RE: SUB 2004-73 -- Final Plat of Midian Shrine Addition

RE: SUB 2004-73 -- Final Plat of Midian Shrine Addition

STAFF REPORT

CASE NUMBER: SUB 2004-73 -- MIDIAN SHRINE ADDITION

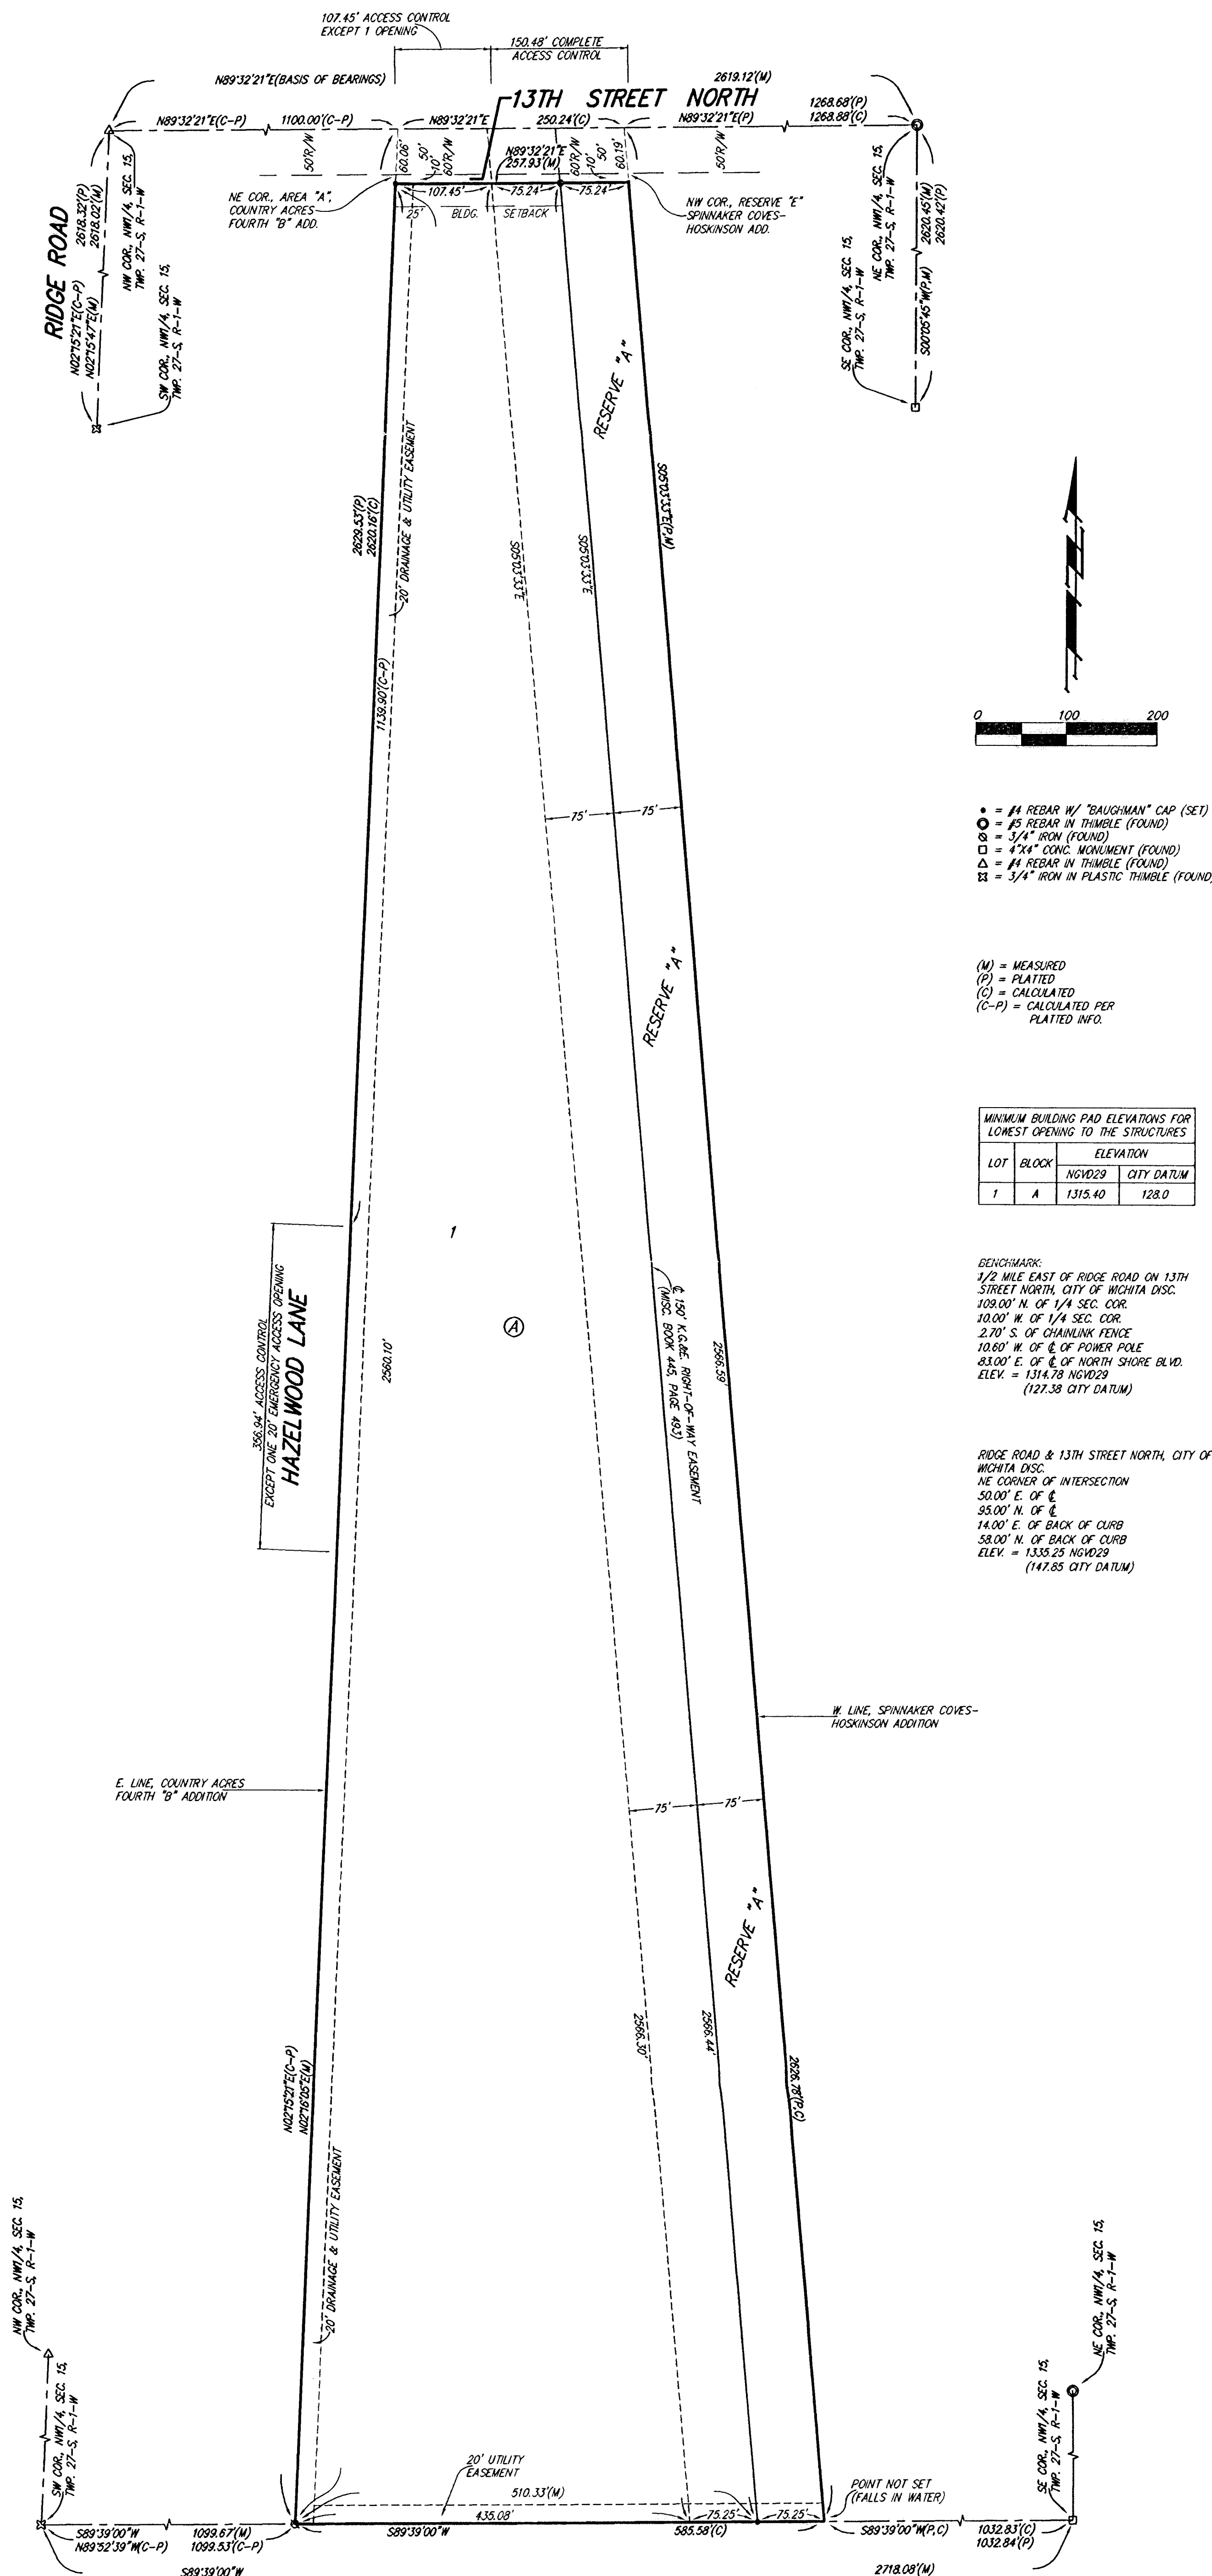
- A. The applicant shall guarantee the extension of sanitary sewer to serve the lots being platted.
- B. If improvements are guaranteed by petition, a notarized certificate listing the petitions shall be submitted to the Planning Department for recording.

- C. Traffic Engineering has requested a petition for future left turn lanes to 13th St. North.
- D. The plat proposes one opening along 13th St. North. The access opening is approved.

- E. City Engineering needs to comment on the status of the applicant's drainage plan. The drainage plan is approved.
- F. Provisions shall be made for ownership and maintenance of the proposed reserves. A covenant shall be submitted regarding ownership and maintenance responsibilities.

- G. For those reserves being platted for drainage purposes, the required covenant which provides for ownership and maintenance of the reserves shall grant, to the City, the authority to maintain the drainage reserves in the event the owner(s) fail to do so. The covenant shall provide for the cost of such maintenance to be charged back to the owner(s) by the governing body.

- H. City Fire Department has requested an emergency access opening extending to Hazelwood in the adjoining property to the west. A 20-ft wide hard paved surface is needed. Standard gating and signing are required per City Fire Department standards.

- I. This property is within a zone identified by the City Engineers' office as likely to have groundwater at some or all times within 10 feet of the ground surface elevation. Building with specially engineered foundations or with the lowest floor opening above groundwater is recommended, and owners

- J. Approval of this plat will require a waiver of the lot depth to width ratio of the Subdivision Regulations. The Subdivision Regulations state that the maximum depth of all non-residential lots shall not exceed three times the width. **A modification has been approved.**

- L. The platting text shall include language that a drainage plan has been developed for the plat and that all drainage easements, rights-of-way, or reserves shall remain at established grades or as modified with the approval of the applicable City or County Engineer, and unobstructed to allow for the conveyance of stormwater.

- S. Recording of the plat within thirty (30) days after approval by the City Council and/or County Commission.
- T. The representatives from the utility companies should be prepared to comment on the need for any additional utility easements to be platted on this property. *Southwestern Bell has requested additional easements.*
- U. The applicant is reminded that a compact disc (CD) shall be submitted with the final plat tracing to the Planning Department detailing this plat in digital format in AutoCAD, or sent via e-mail to MAPD (cholloway@wichita.gov). This will be used by the City and County GIS Department.

The plat has denoted the emergency access opening as requested.
